Trailer Driving Assist Active Message Displayed Without a Trailer Connected

Service Category Audio/Visual/Telematics

Section Park Assist/Monitoring

YEAR(S)	MODEL(S)	ADDITIONAL INFORMATION
2024	Tacoma

Figure 1.

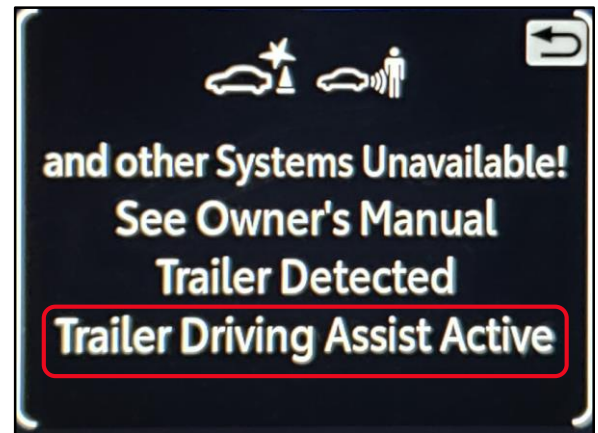
1. Confirm the condition exists.
Is the Trailer Driving Assist Active message displayed without a trailer connected, as shown in Figure 1?
 - **YES** — Continue to step 2.
 - **NO** — This bulletin does NOT apply. Continue diagnosis using the applicable Repair Manual.
